PUBLIC INTEREST REVIEW FOR GROUNDWATER APPLICATIONS

TO: Water Rights Section Date 10/07/2015
 FROM: Groundwater Section Jen Woody
Reviewer's Name
 SUBJECT: Application G- 18003 Supersedes review of 8/13/2015
Date of Review(s)

A. GENERAL INFORMATION: Applicant's Name: Woodburn Organic Farms LLC County: Marion

A1. Applicant(s) seek(s) 0.49 cfs from 1 well(s) in the Willamette Basin,
Molalla - Pudding River subbasin Quad Map: Woodburn

Proposed well #3: G18003 and Pudding River

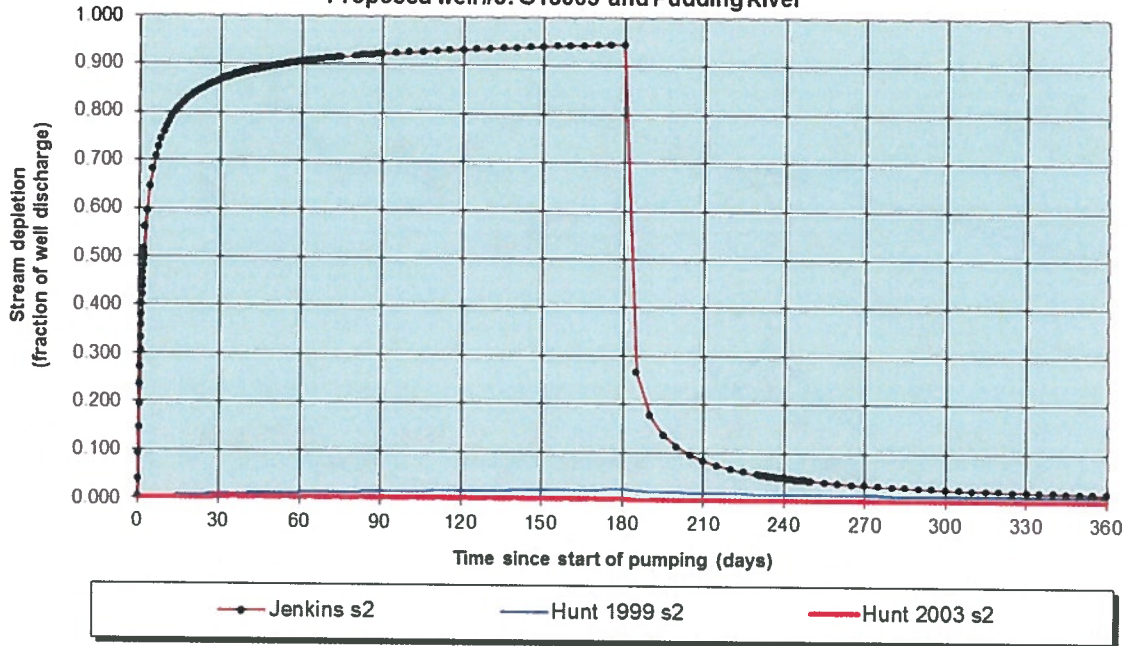
The Willamette Silt acts as a resistor to streambed flux. Calculated stream depletion using the Hunt 2003 model indicates interference with the Pudding River at 30 days is much less than 25% at both wells.
